GEORGETOWN-SCOTT COUNTY PLANNING COMMISSION

**AGENDA
JULY 8, 2021
6:00 p.m.**

Staff Report to the Georgetown-Scott County Planning Commission

CHERRY BLOSSOM, PHASE 9

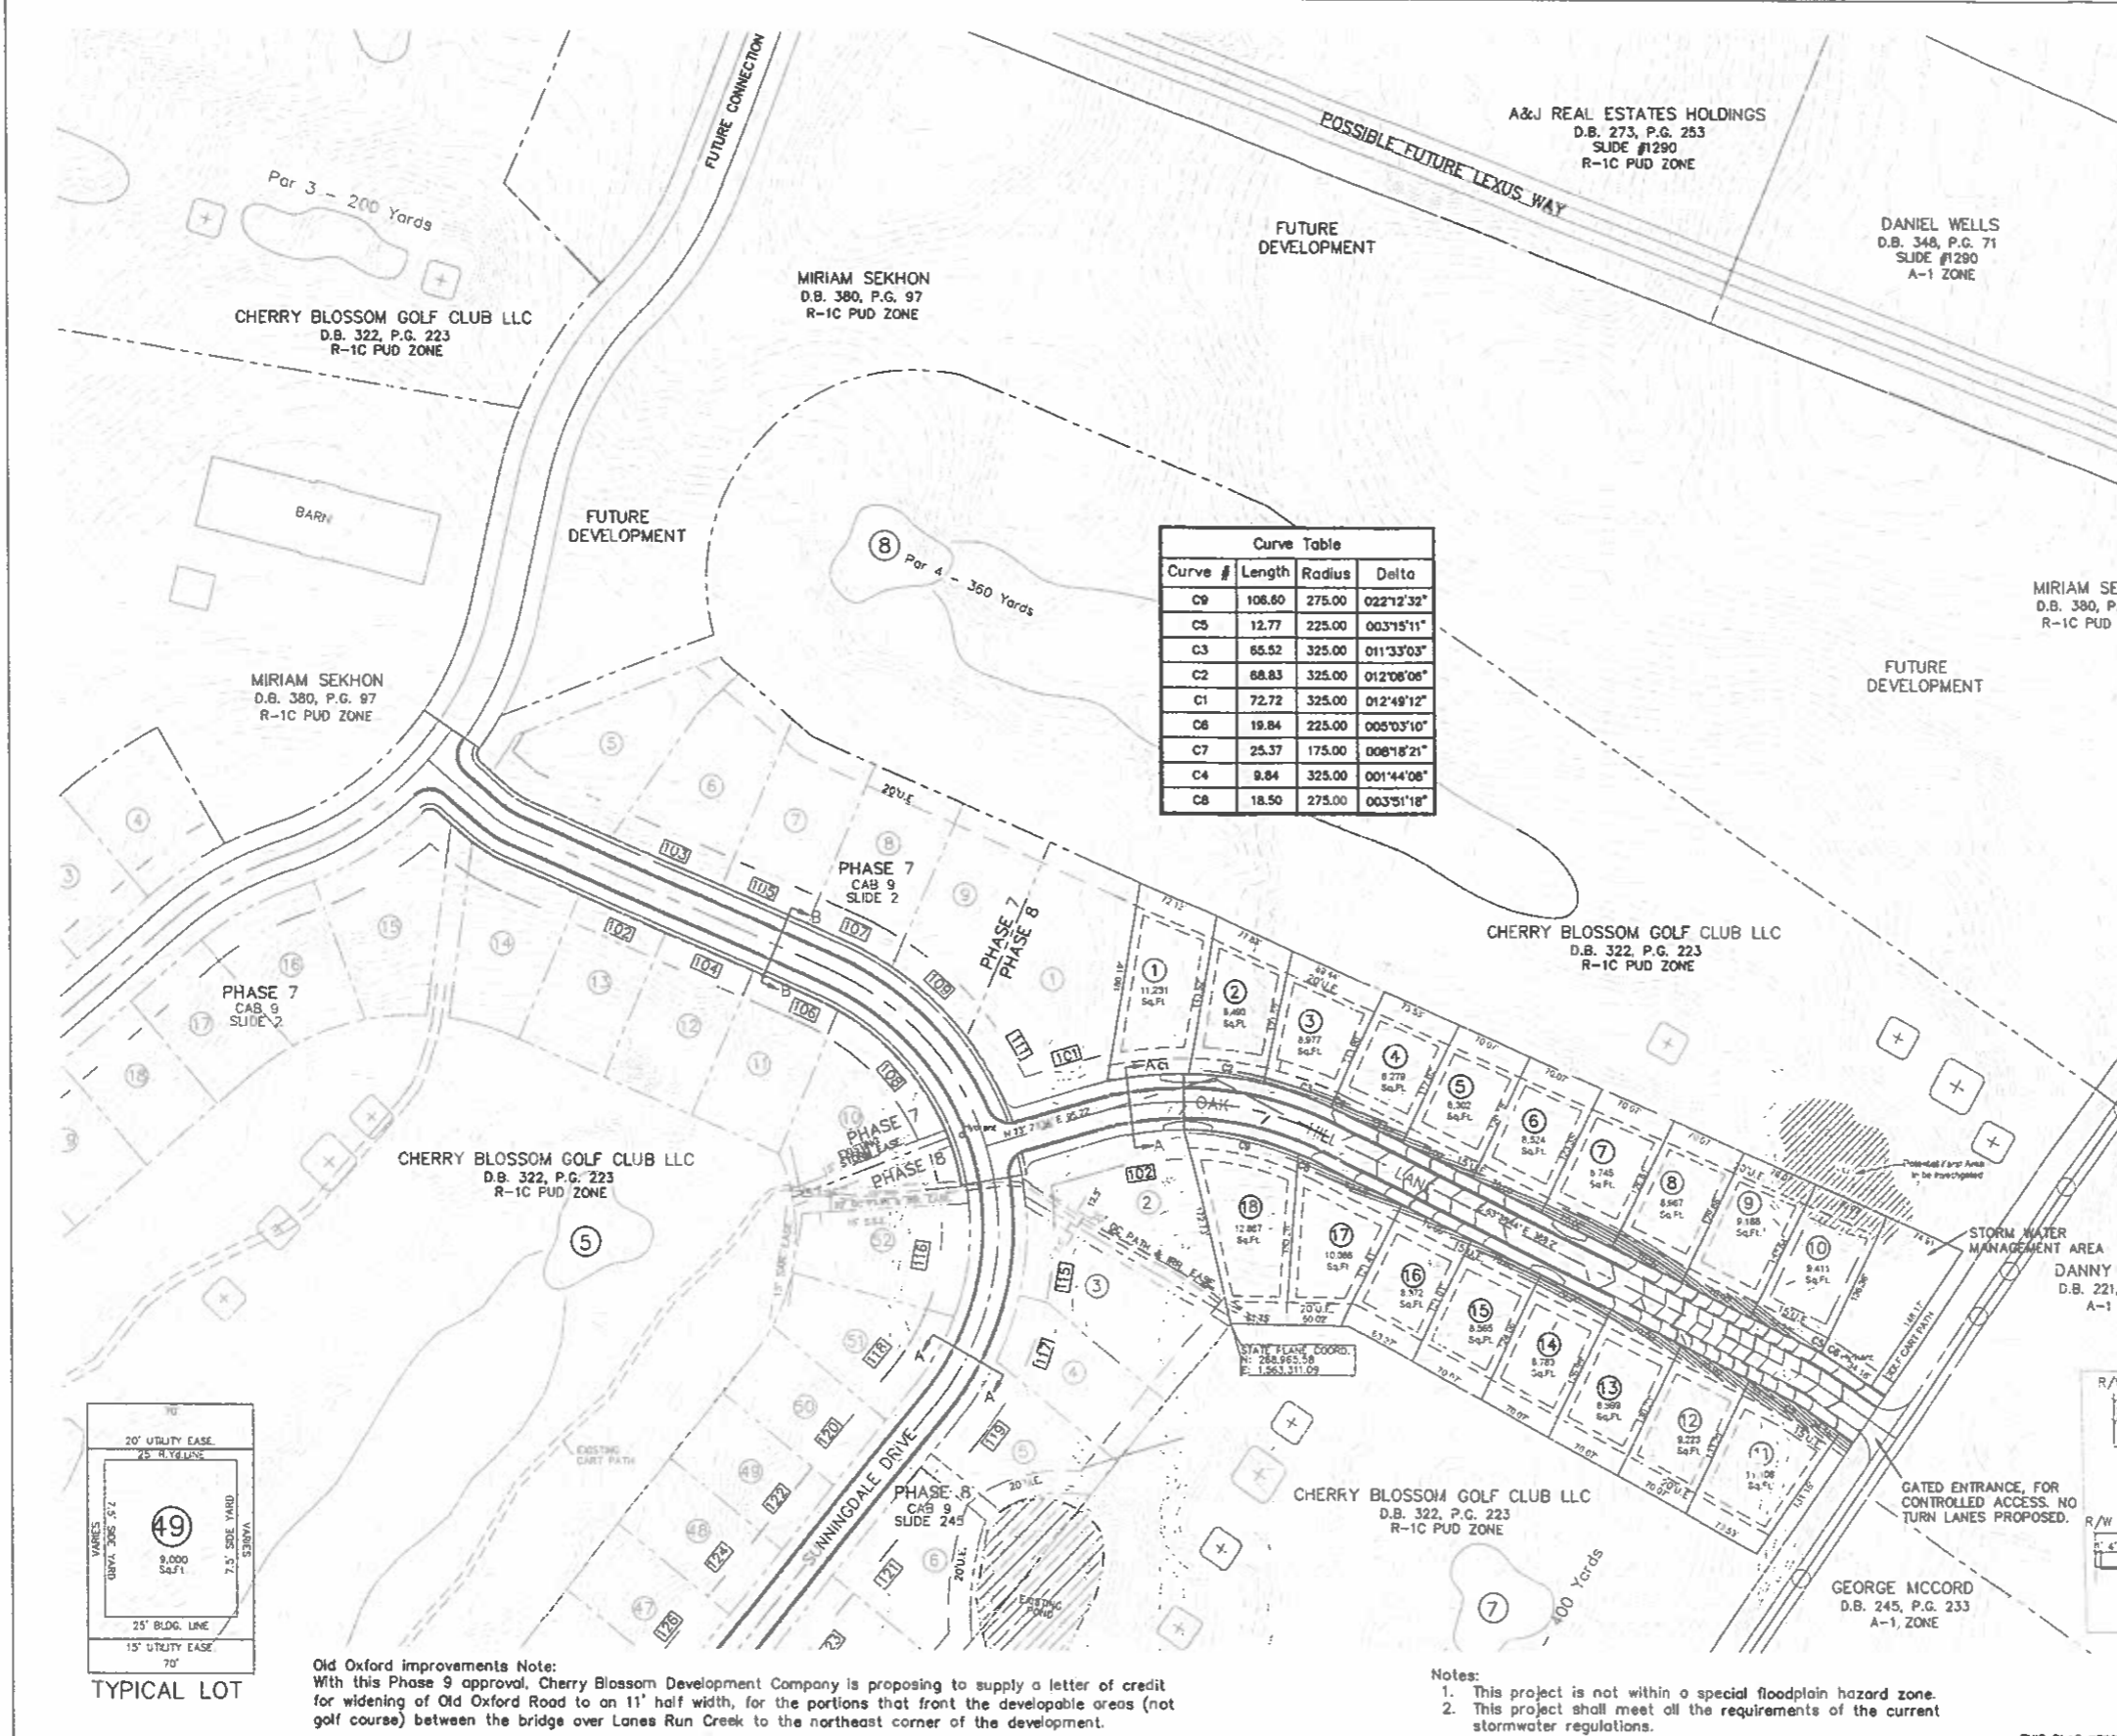
The layout, width, size of the proposed lots conforms with the underlying zoning and is consistent with previous approvals. A condition of approval of the previous phase (phase 8) also stated that "Any further approvals will require a connection to Old Oxford Road unless the applicant coordinates with the City and other property owners to provide these improvements collectively."

The applicant is proposing to make the connection to Old Oxford Road, but to install a gated controlled access. They have asked to waive the construction of turn lanes on Old Oxford due to their proposal to install a gate limiting use of the access to emergency vehicles, thru a manual or electronic pad locked gate of some sort.

The applicant has further proposed to provide a letter of credit for the widening of Old Oxford to the required 11' width from centerline, for the portions that front the developable areas (not golf course) between the bridge over Lanes Run Creek to the northeast corner of the development.

Staff is open to the option of a gate, but since this is proposed as a public street, the gate would need approval from the Planning Commission and the City at the time of dedication. Staff, however, would prefer an open access connection to improve traffic flow in the area.

Staff would also recommend the applicant provide a letter of credit for widening the entire length of Old Oxford along their frontage. The turn lanes are optional based on whether the access from Old Oxford is to be controlled. A turnaround area would likely be needed inside the gate for utility trucks and other large non-emergency vehicles if the gate were to be fixed.

2. Applicant shall provide a gate accessible by emergency services at the entrance from Old Oxford Road. Planning Commission Engineer shall review the need for a turnaround at the gate depending on final location. Gate shall be approved by the City prior to dedication of street or this section of new street shall remain private. If the gate is not constructed, the developer shall submit a traffic analysis to determine the need for turn lanes at this entrance. The developer shall pay for any turn lanes determined to be required at the entrance on Old Oxford.

3. Applicant shall post letter of credit or cash surety for widening of Old Oxford to 11' from centerline along length of frontage.
4. Prior to any construction or grading, the applicant shall meet with the Planning Commission Engineer to review construction policies and establish inspection schedules.

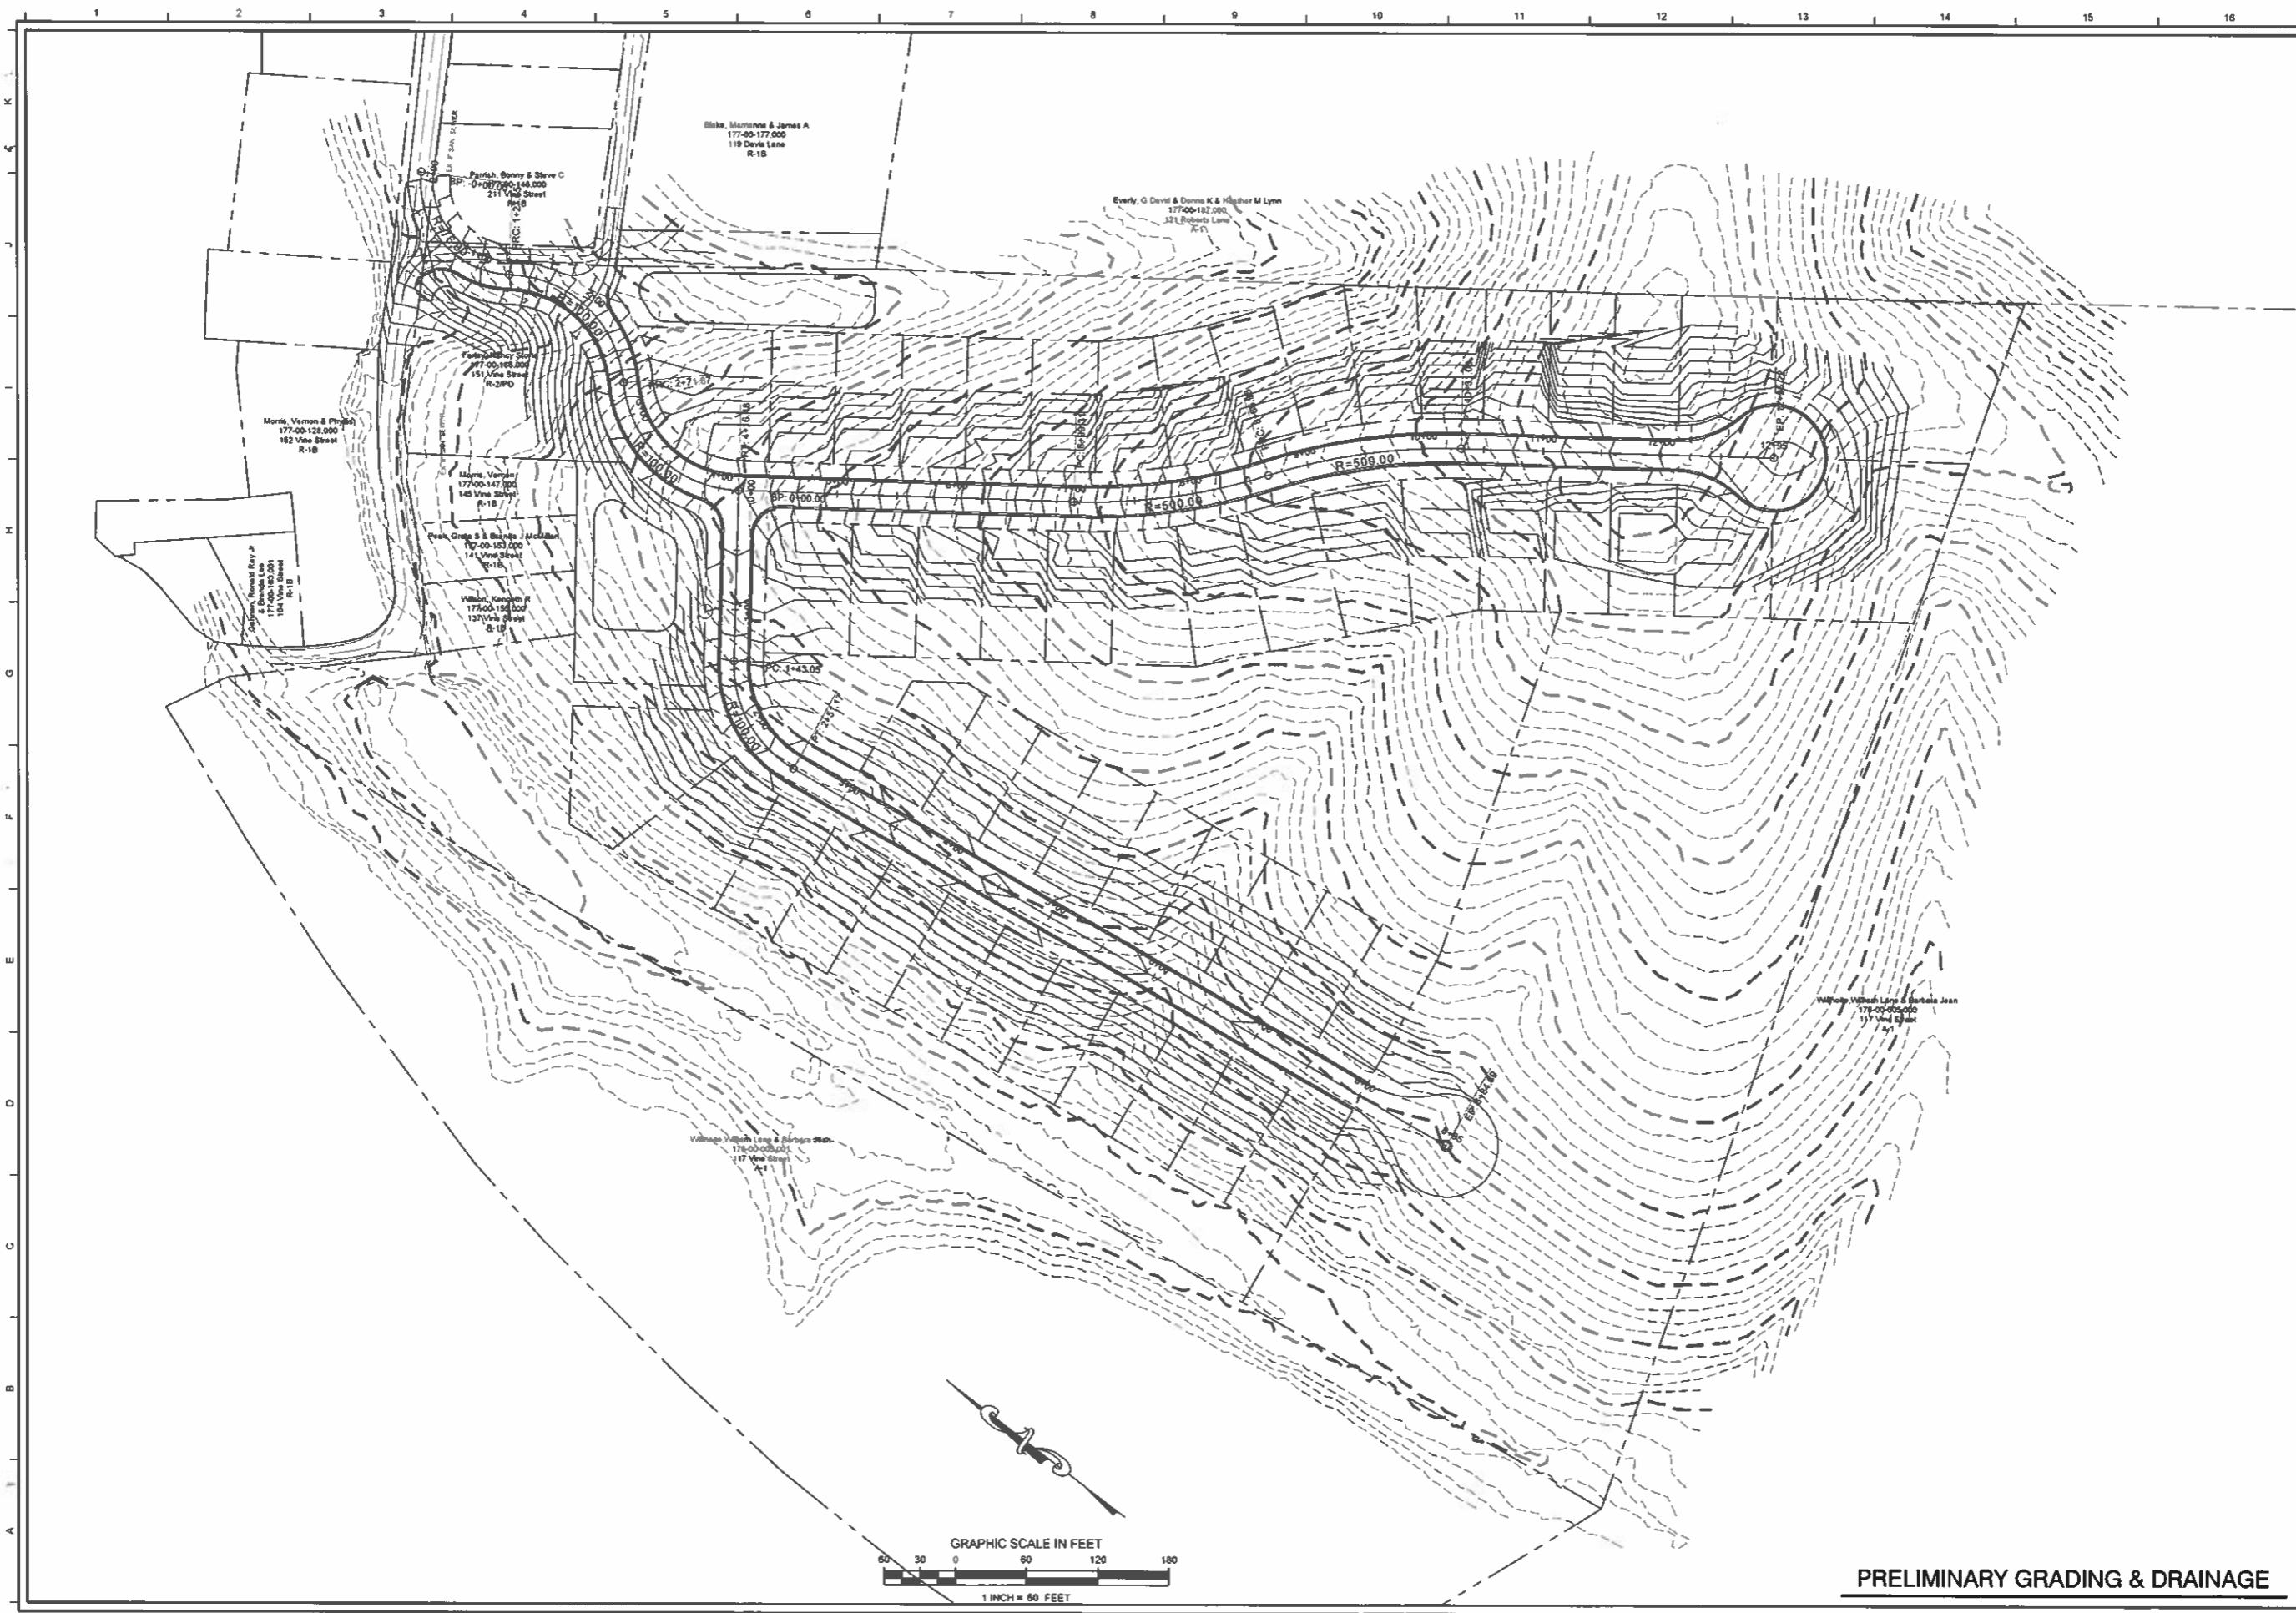
The net density of the proposed development (3.91 units/net acre) meets the requirements of the *Zoning Ordinance*. The Applicant will have to make some minor corrections to the site statistics prior to the Final Plat's recording including the calculation of net acreage. The Planning Commission calculates net acreage as the gross acres minus the right-of-way.

The Preliminary Grading Plan submitted as part of this application shows that the proposed development is possible. Staff still has some concerns that can be corrected through the construction plans that would follow a preliminary approval. The proposed roads will need to meet all requirements of the *Subdivision and Development Regulations* including slopes no greater than 10% and turning radii.

The element measurements on the typical road section shown on the PSP do not add up to the listed 50 feet of right-of-way. This will need to be corrected for any future construction plans and Final Subdivision Plat. Staff will need a cul-de-sac detail as part of future construction plans and Final Subdivision Plat. There are some discrepancies between the preliminary grading plan and the road profile sheet that will need to be corrected moving forward.

10. Planning Commission staff shall not record any plats creating buildable lots for the Project Site until the Vine Street and Davis Lane improvements the City has proposed are completed.

11. The Construction Plans and Final Subdivision Plat shall demonstrate that the requirements of the Landscape and Land Use Buffer Ordinance are met. Single-family residential developments must provide between 10-15% canopy coverage depending on the trees that will be protected through construction.
